Design Change Request Sheet

Parts Name : Door inner panel	Sub System : 48A-72	System : A
-------------------------------	---------------------	------------

Design Change Request Data Sheet

HEADELINING ASSY × WINDSHILD

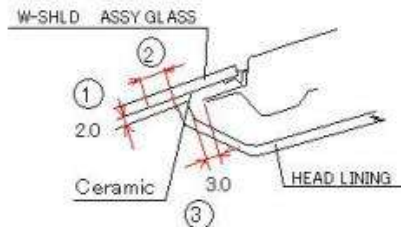
① GAP

UP TO 2.0

② HEADELINING ASSY ×
 CERAMICS Parallel

UP TO 2.0

③ HEADELINING ASSY ×
 BODY GAP

TAUCHING
 REJECTION

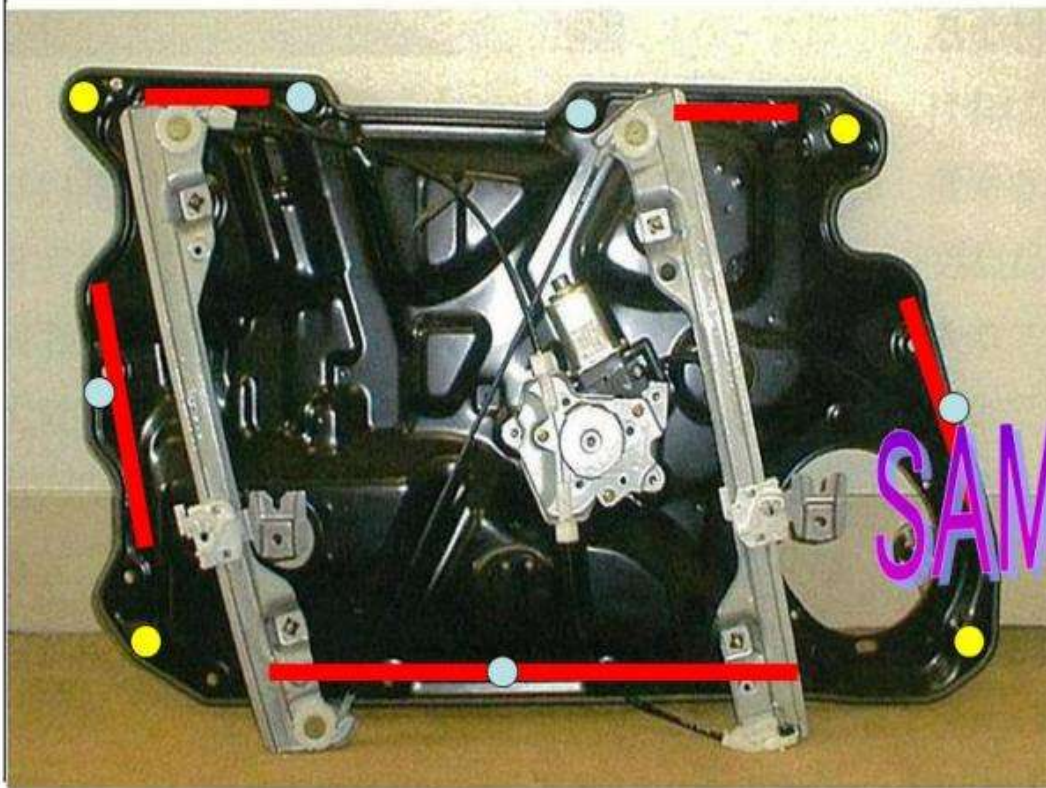
Door Panel Inner set on the Door inner frame with 18 Bolts now.

For assembly time saving, combination fitting required.

Need change combination fitting the bolts, clips and the Adhesive tape. At least 4 bolts needed.
